V-81 (2018) 06/11/2018 **THOMAS DETACHED GARAGE** 2562 HOLLYCREEK DRIVE MARIETTA, GA 30062 OVERALL SITE PLAN HOLLYCREEK DRIVE EGEINED COBB CO. COMM: DEV. AGENCY ZONING DIVISION JUL 1 2 2018 1) OVERALL SITE PLAN 1" = 30-0"

APPLICANT:	Brandon Thomas	PETITION No.: V-81			
PHONE:	678-920-3612	DATE OF HEARING:	09-12-2018		
REPRESENTA	TIVE: Brandon Thomas	PRESENT ZONING:	R-15		
PHONE:	678-920-3612	LAND LOT(S):	816		
TITLEHOLDEI	R: Brandon L. Thomas and Gerrie B. Thomas	DISTRICT:	16		
PROPERTY LO	OCATION: On the east side of Holly	SIZE OF TRACT:	0.34 acres		
Creek Drive, east of Holly Springs Road		COMMISSION DISTR	ICT: 2		
(2562 Holly Creek Drive).					
TYPE OF VARIANCE: 1) Waive the front setback from the required 35 feet to 33 feet (existing); 2) waive the					
side setback from the required 10 feet to nine (9) feet adjacent to the north property line (existing); and waive the					
required setbacks	s for an accessory structure over 1,000 squa	are feet (proposed approxir	mately 1,102 square foot garage)		
from the required	1 100 feet to 30 feet from the rear, to 15 fee	et adjacent to the south proj	perty line, to 60 feet from the

APPLICANT: Brandon Thomas **PETITION No.:** V-81

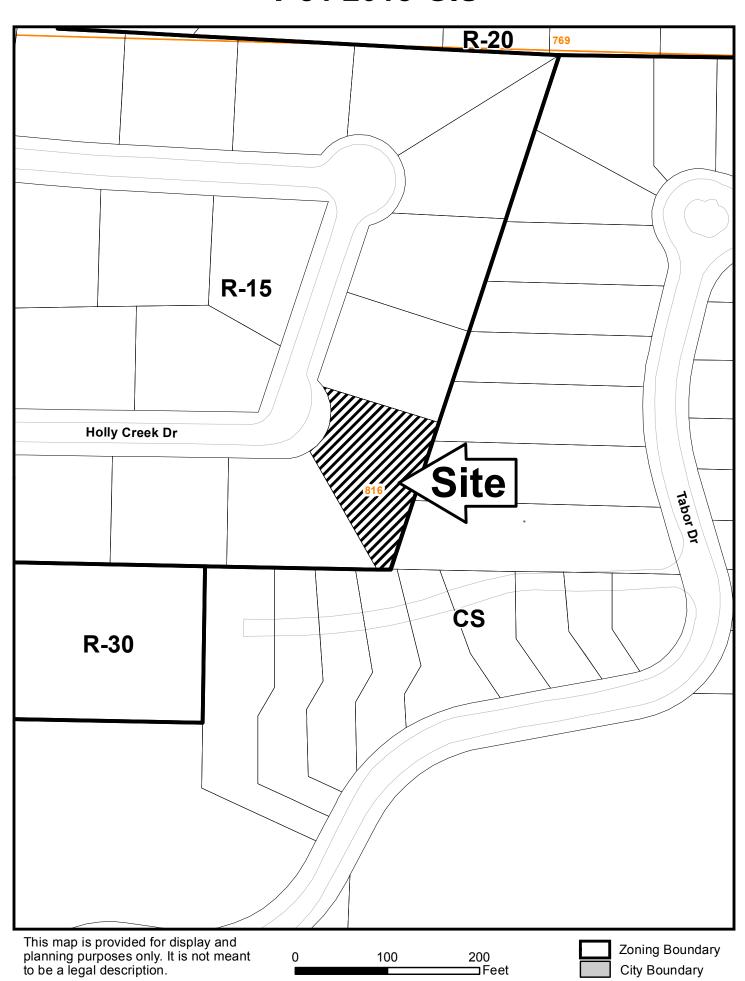
SITE PLAN REVIEW: If this variance request is approved, a subdivision plat revision must be recorded prior to the issuance of the certificate of occupancy showing all improvements on the lot along with any approved setback reductions, and referencing the variance case in the standard plat revision note. The surveyor must submit the plat to the Site Plan Review Section, Community Development Agency for review an approval prior to recording. Call 770-528-2147.

STORMWATER MANAGEMENT: All roof downspouts must discharge to the ground at the structure to maximize the overland flow path of runoff to the property line.
